Operational change

90-series – Maneuvering area expanded and placement of handling gear

- *Valid from: 08.09.2025*
- *Valid to: UFN*
- *Version number: 03-2025*

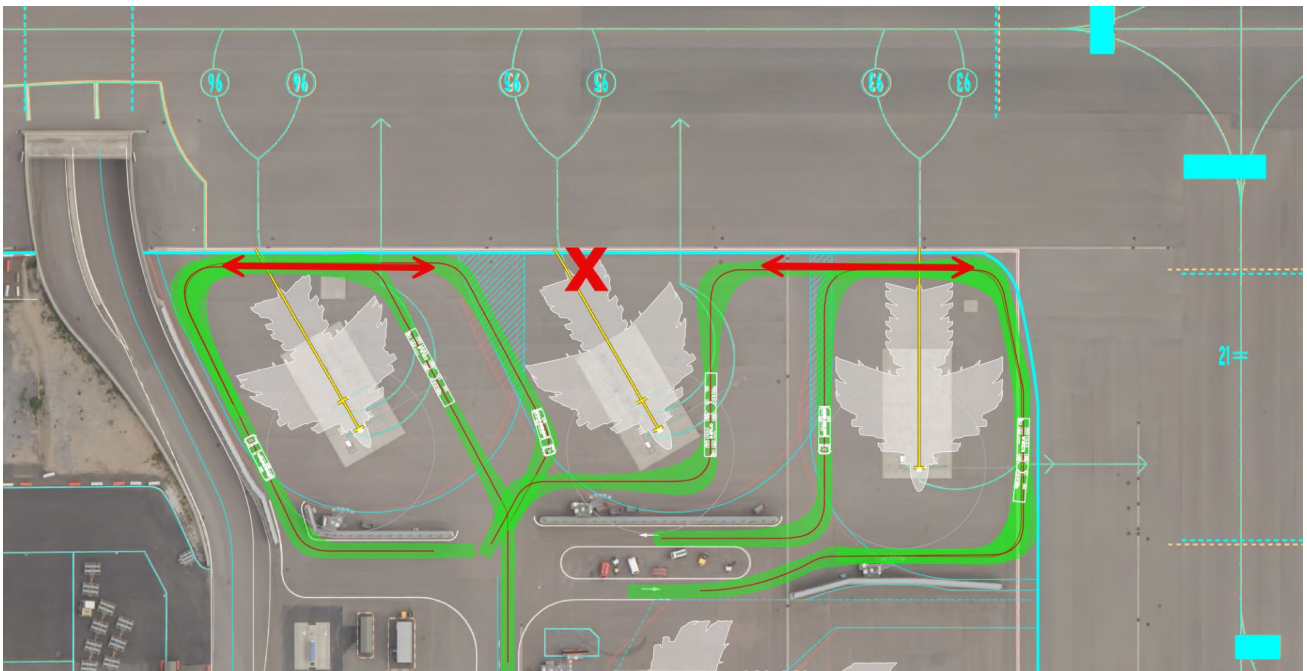
There has been limited space for buses and tankers at stands 93, 94, and 96. This resulted in vehicles crossing the maneuvering area boundary without approval. As a result, a risk analysis has been conducted, the maneuvering area boundary has been adjusted, and a service test has been carried out in the area

The maneuvering area boundary has been moved eastward at stand 93. This provides buses and tankers with better space to operate in the area. However, there is still limited space behind the aircraft for larger vehicles, so operators are urged not to park equipment behind the aircraft, as this will block access for buses and tankers

Equipment must not be parked behind the aircraft or on the north side of the 90-series, as this will block the driving route for buses and/or tankers.
